STAFF REPORT: 01-22-2020 MEETING

APPLICATION NUMBER: 19-6592

ADDRESS: 15053 FAUST

SCOPE: DEMOLISH EXISTING GARAGE, ERECT NEW GARAGE

Proposed exterior light fixture

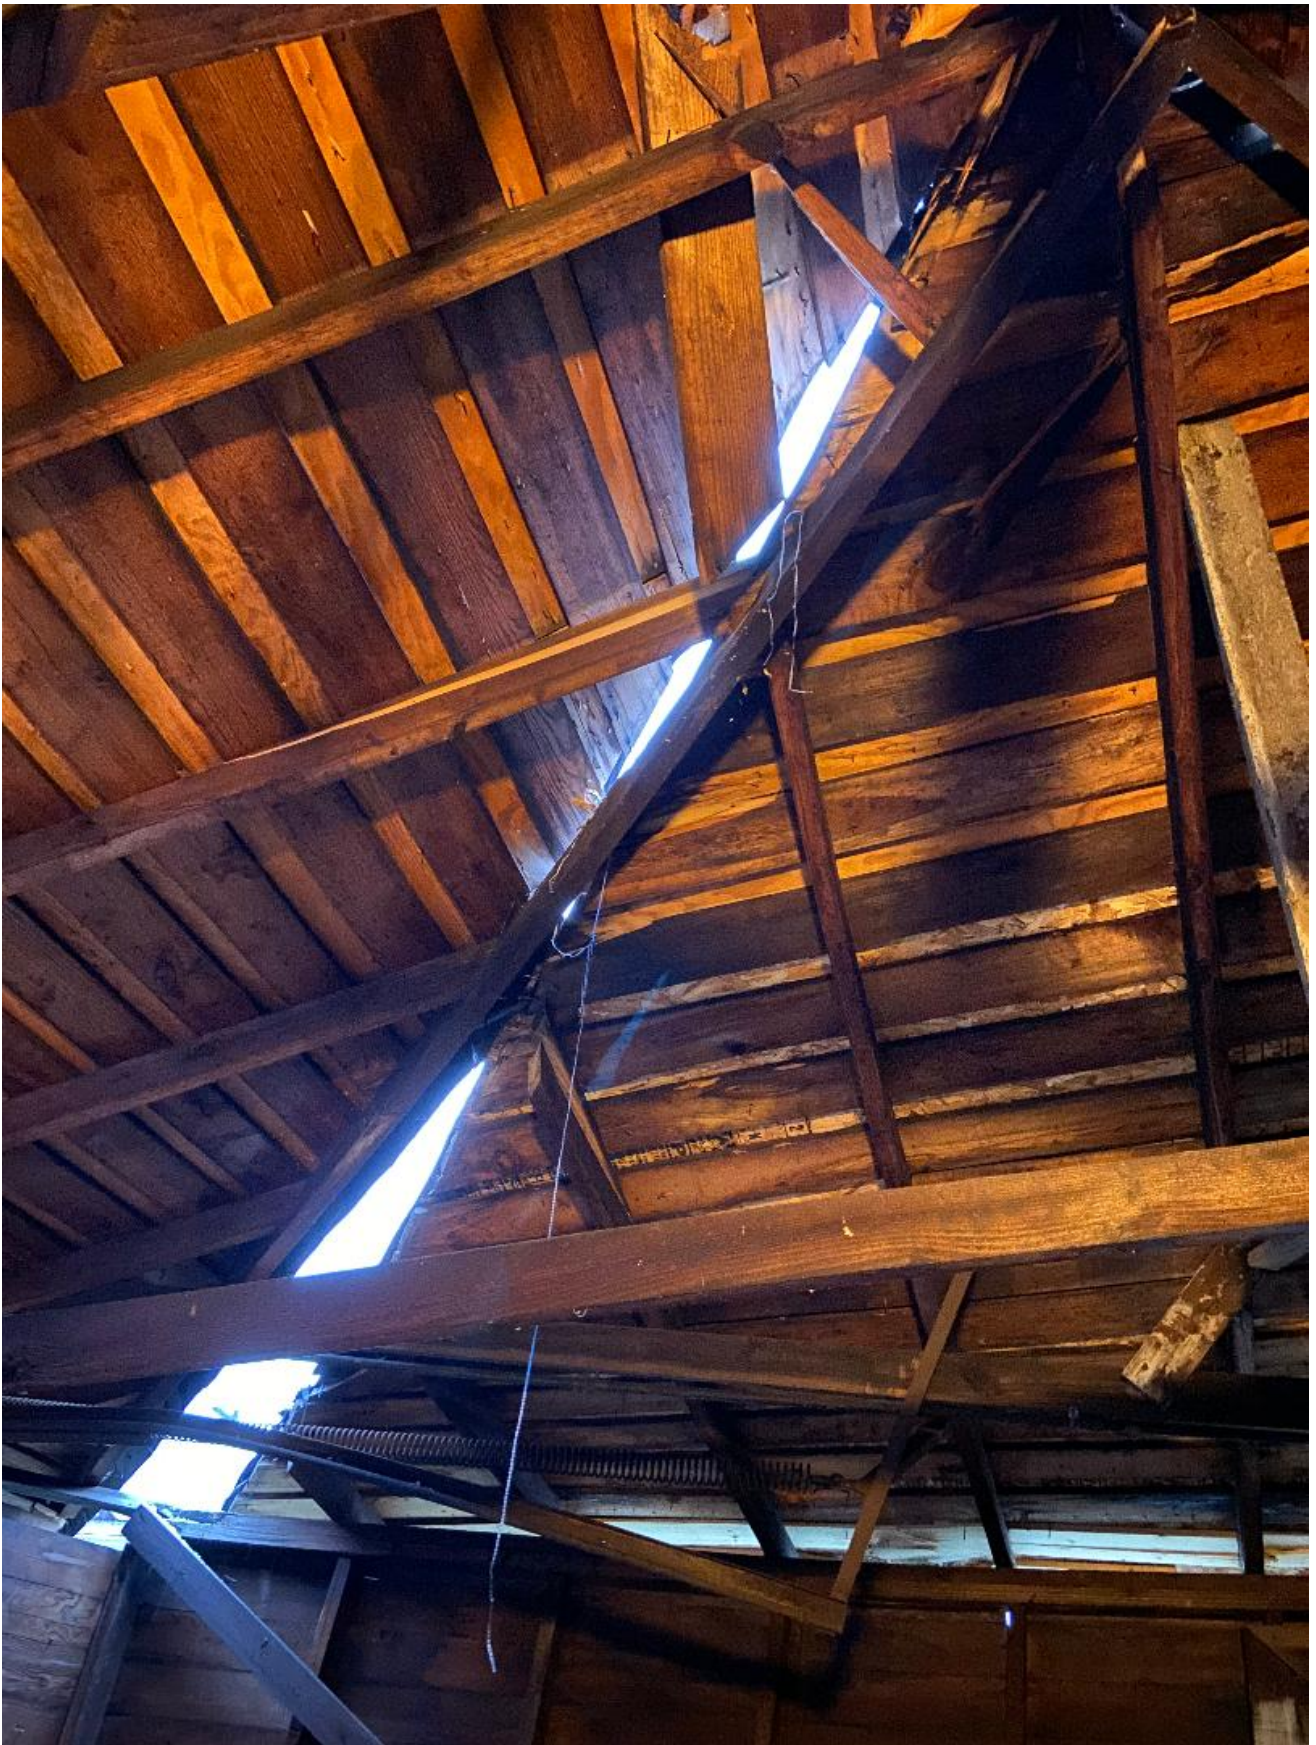
We are requesting that you provide the catalog cuts for the proposed doors and exterior lighting.

15053 FAUST
DETROIT, MI

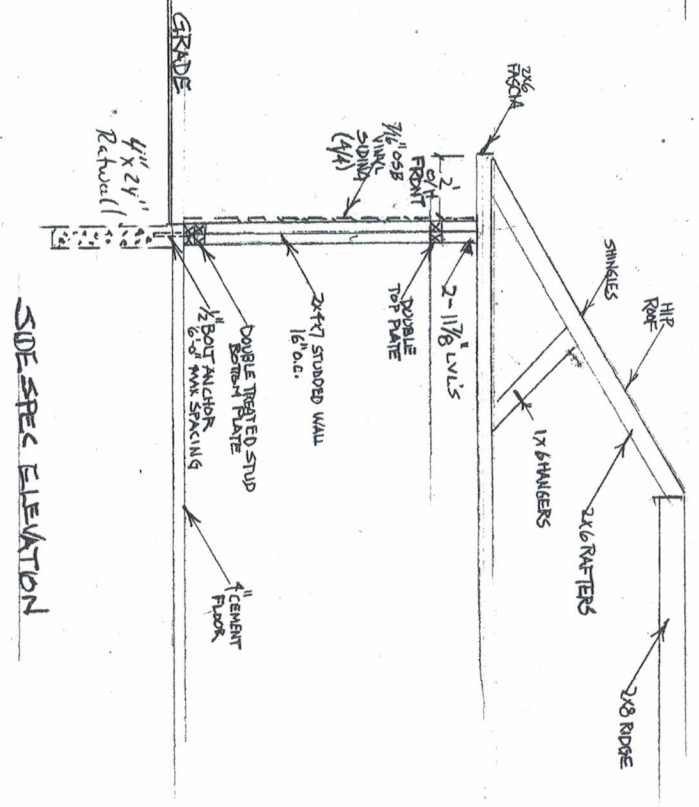
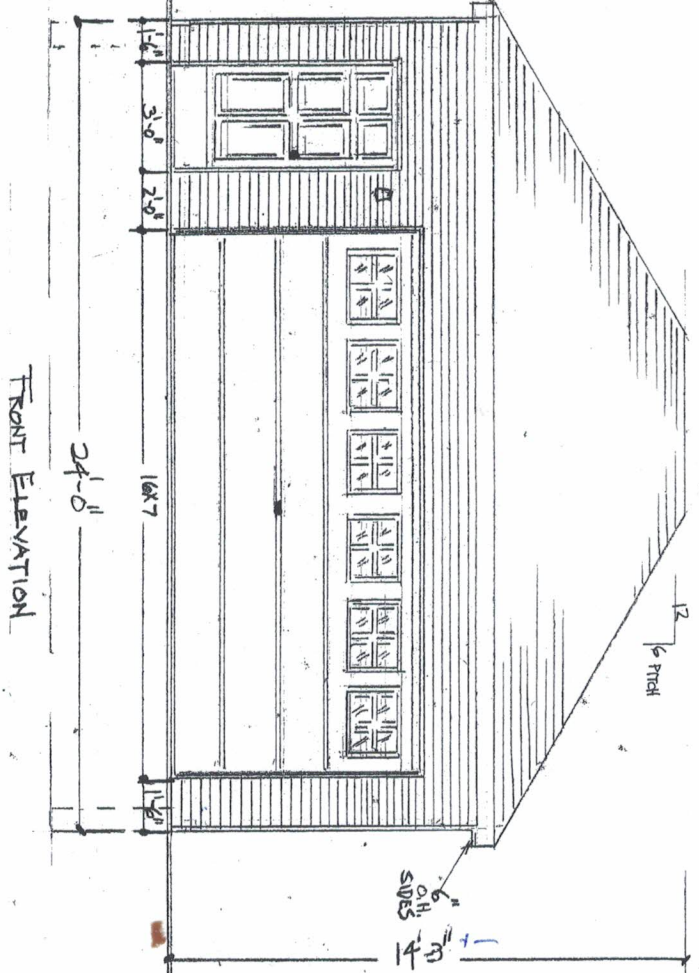
- A single overhead door is a contemporary design option and is not a design feature of older, historic garages.
- Even though a new garage may be constructed, as it is being built in a historic district, double doors are the most appropriate design solution so the new structure aesthetically fits into the historic environment. Per Rosedale Park's Elements of Design: "*Garages, when original, often correspond in materials to the main body of the dwelling, but are of modest, one-story, simple box design with single or double-doors.*"

- Vinyl siding, due to its materiality (plastic) and associated appearance: visible seams, limited widths and profiles, and limited colors, does not mimic wood siding and therefore, is not compatible with the historic materials on the house and not appropriate within a local historic district.

- Two overhead doors shall be designed for the garage. Ideally, the existing doors should be reused. If the severity of deterioration requires replacement, the new feature shall match the old in design, color, texture and other visual qualities and, where possible, materials (i.e., the new doors shall have a panel and glass arrangement similar to the existing doors).
- The applicant will submit the catalog cut for the man door and garage doors.

- The exterior siding will be lapped wood or fiber-cement board.
- The exterior color scheme will correspond with Color System D (for English Revival style buildings).
